Intersection ID: 44214	Main Street: NATIONS_FORD_RD	Cross Street: TYVOLA_GLEN_CR	Location:	S
ADA ID: 49E44076D87E	Ramp Type: PerpDiag	Initial Pass/Fail: Fail	Overall Compliance: No	Severity Score: 21.25

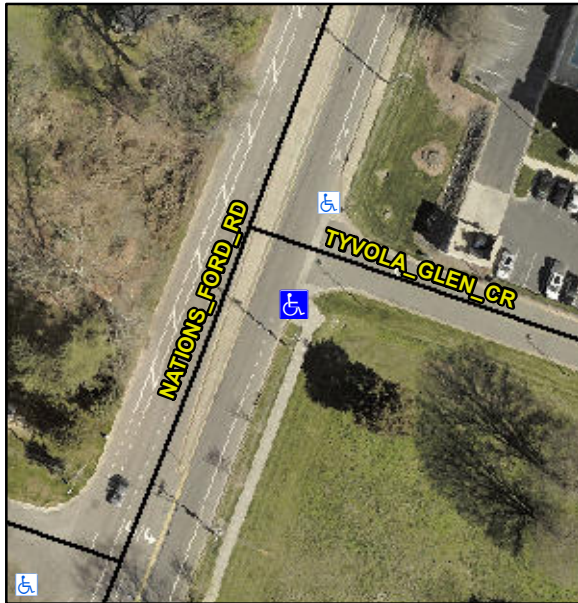
Not Found, R304.5.1, R304.5.3

Compliance	Description	Data	Compliance	Description	Data
N/A	Ramp Length (in)	93.0	Yes	Ramp Slope (%)	5.3
No	Ramp Width (in)	37.0	No	Ramp XSlope (%)	6.1
N/A	Flare Type LT	N/A	N/A	Flare Type RT	N/A
N/A	Flare Slope LT (%)	N/A	N/A	Flare Slope RT (%)	N/A
N/A	Flare Traversable LT?	N/A	N/A	Flare Traversable RT?	N/A
N/A	Landing Length (in)	N/A	N/A	DWS Provided?	N/A
N/A	Landing Width (in)	N/A	N/A	DWS Contrast?	N/A
N/A	Landing Slope (%)	N/A	N/A	DWS Length (in)	N/A
N/A	Landing X Slope (%)	N/A	N/A	DWS Full Width?	N/A
N/A	Landing Curb? (Y/N)	N/A	N/A	DWS Offset (in)	N/A
N/A	Shared Landing?	N/A			
N/A	Gutter Ponding?	N/A	N/A	Gutter Slope (%)	N/A
N/A	Gutter Lip Ht (in)	N/A	N/A	Gutter X Slope (%)	N/A
N/A	Painted X Walk1?	No	N/A	Painted X Walk2?	No
	X Walk 1 Direction	To NE		X Walk 2 Direction	To W
N/A	X Walk 1 Width (in)	N/A	N/A	X Walk 2 Width (in)	N/A
	X Walk 1 Slope (%)	0.2		X Walk 2 Slope (%)	1.6
	X Walk 1 X Slope (%)	0.0		X Walk 2 X Slope (%)	0.9

Remove & Replace Curb Ramp With Two New Directional Ramps or Equivalent.
